# TECHNICAL SERVICE BULLETIN

Classification: EL23-004	Reference: NTB23-040	Date: May 3, 2023
-----------------------------	-------------------------	----------------------

## “CHARGE TIME (EST.)” TIMES NOT DISPLAYED ON THE COMBINATION METER

**APPLIED VEHICLES:** 2023 LEAF (ZE1)  
**APPLIED DATES:** Built on or before November 6, 2022

Figure 1

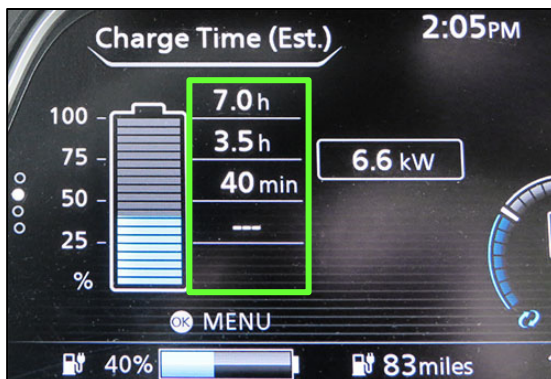
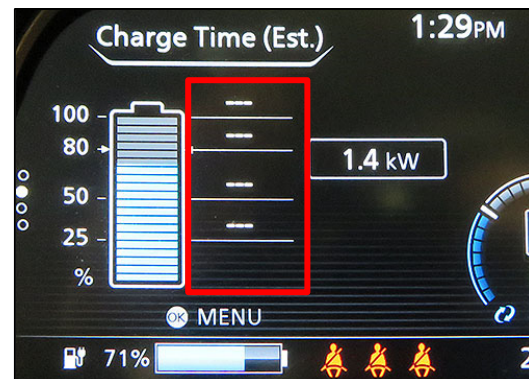
The “Charge Time (Est.)” times shown in Figure 1 are not displayed on the Combination Meter, as shown in Figure 2.

Replace the Combination Meter using the **SERVICE PROCEDURE** on page 2.
